<b>Docket Number:</b>	02-AFC-01C
<b>Project Title:</b>	Sonoran Energy Project (formerly Blythe Energy Project Phase II) - Compliance
<b>TN #:</b>	210578
<b>Document Title:</b>	Project Owner's Comments on Staff's Preliminary Staff Assessment
<b>Description:</b>	N/A
<b>Filer:</b>	Judith Warmuth
<b>Organization:</b>	Stoel Rives LLP
<b>Submitter Role:</b>	Applicant
<b>Submission Date:</b>	3/1/2016 3:31:36 PM
<b>Docketed Date:</b>	3/1/2016

**Re: Sonoran Energy Project, Petition to Amend (02-AFC-1C)  
Project Owner's Comments on Staff's Preliminary Staff Assessment**

#### **a. VFR Sectional Chart Markings and Other FAA Information**

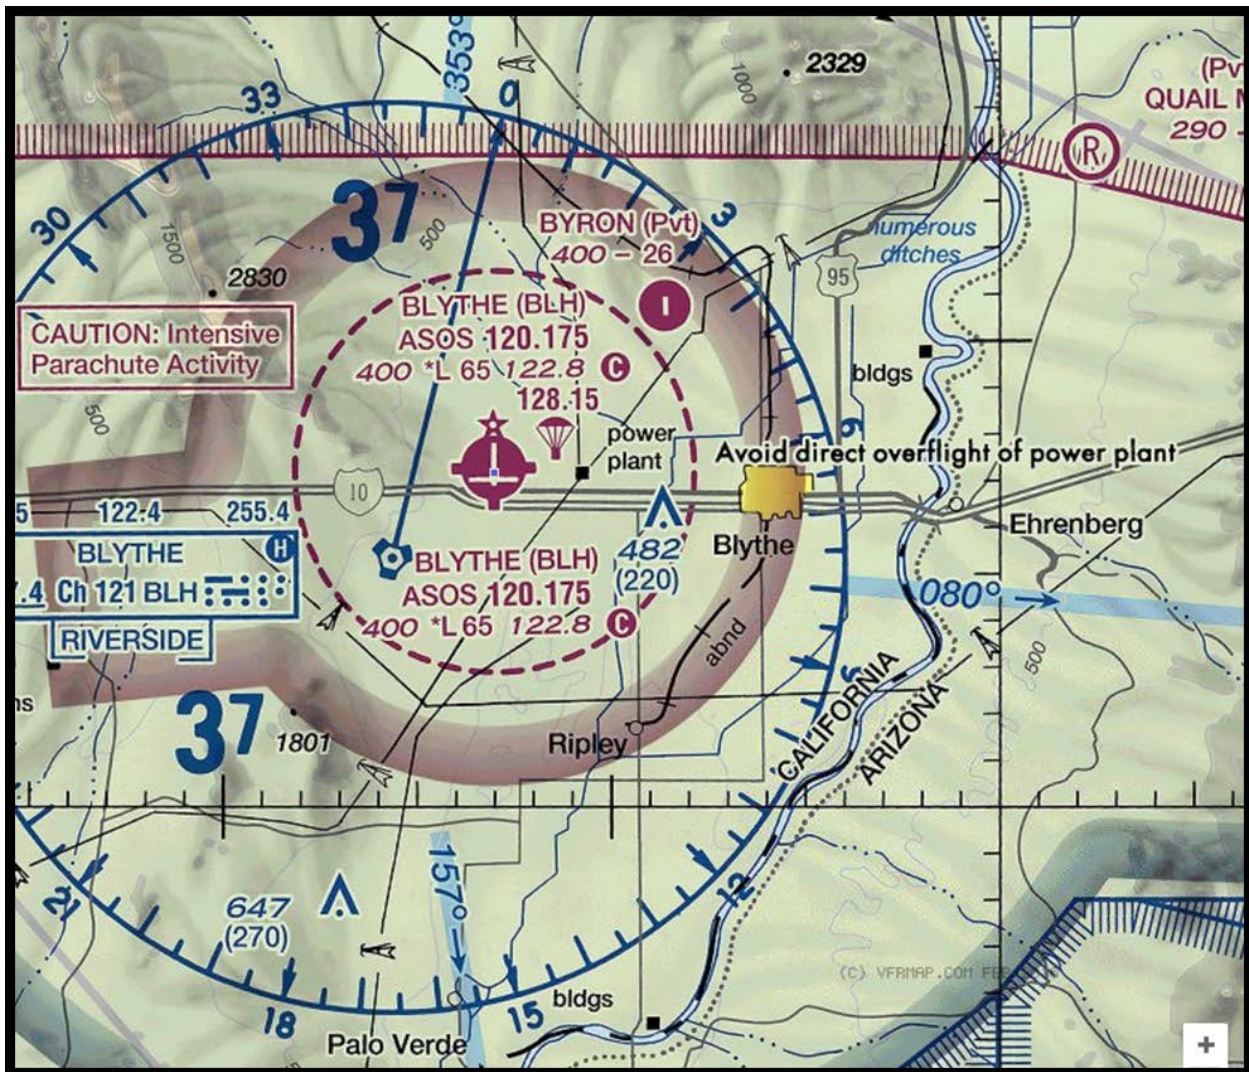
Aviation safety in the vicinity of the current generating facility adjacent to the proposed site is provided by the FAA and the airport in a manner consistent with the methods used nationwide to identify potential flight risks to pilots. Specifically, the Visual Flight Rules

(VFR) charts contain information on parachute drop areas/activity, bird concentrations, power plants and transmission lines among many others. The current VFR Sectional chart for Blythe airport shown below (AirNav.com 2/24/2016) provides information regarding the existing BEP facility. Specifically, the location of the BEP facility is identified with the notation “power plant,” and an additional notation states “Avoid direct overflight of power plant.”

Since the current notification methods provide a high level of awareness to pilots as to the location of the existing power plant and a resultant safe flying environment at Blythe airport, it is recommended that the same methods be employed to assure aviation safety for the SEP.
